Service Campaign Bulletin

Campaign No. 2007100004, February 2009

SUBJECT: **MODELS 203/211/220 4MATIC**
MODEL YEARS 2005 - 2007
REPLACE TRANSFER CASE

Figure 1

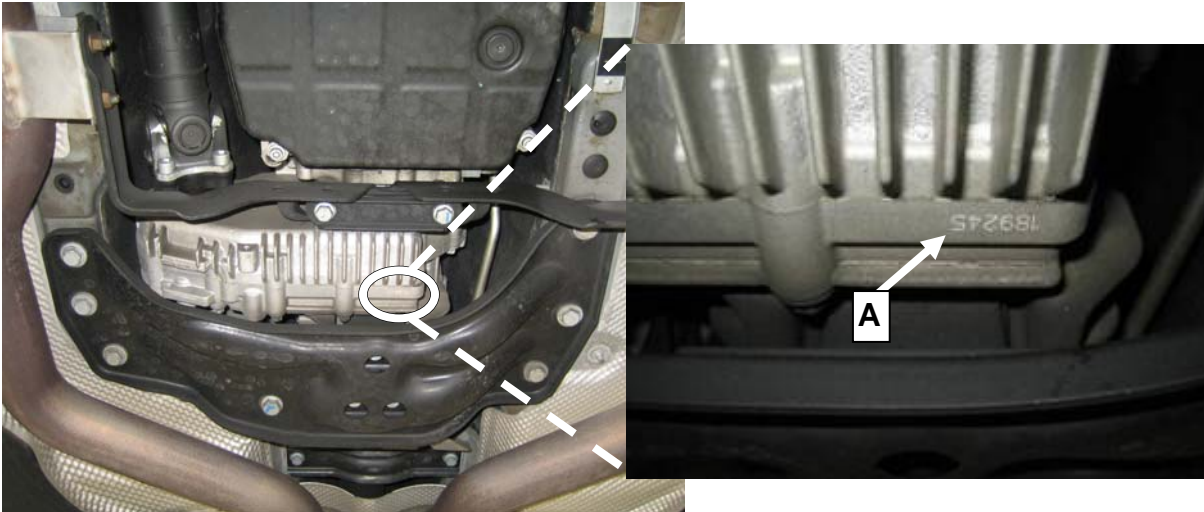
1. Remove rear engine compartment paneling.
2. Check serial number at transfer case (A, Figure1)
 - a) If serial number is **between** 115925 and 137342: **Carry out work procedure.**
 - b) If serial number is **not** between 115925 and 137342: Reinstall rear engine cover - **end measure.**

Do **not** replace transfer case if numbers 0085 are indicated after the serial number regardless if transfer case falls in the serial number range or not.

Figure 2

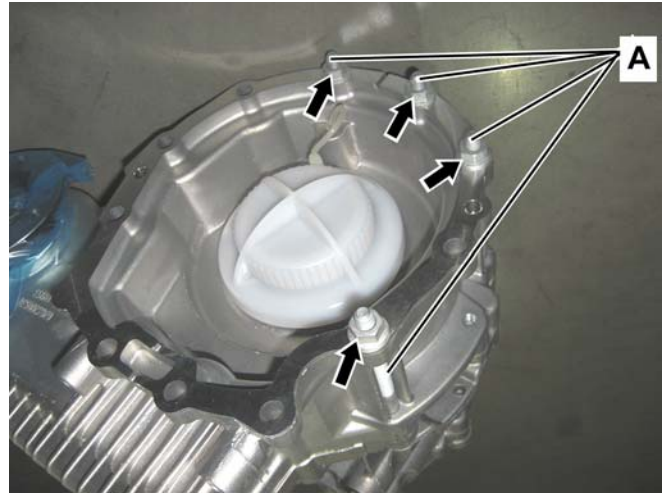
- Secure old transfer case together for shipping using 4 transport bolts (A, Figure 2) and 4 nuts (arrows) included with new transfer case. Torque nuts (arrows) to 25 Nm.
- Ensure removed transfer case is returned in same packaging that contained the new one:
 - Ensure that the old transfer case is not damaged during removal or packaging.
 - The supporting card board inserts provided must be reused during packaging. The old transfer case must be packaged in the same manner as was the new one (refer to Figures 3-6 below).
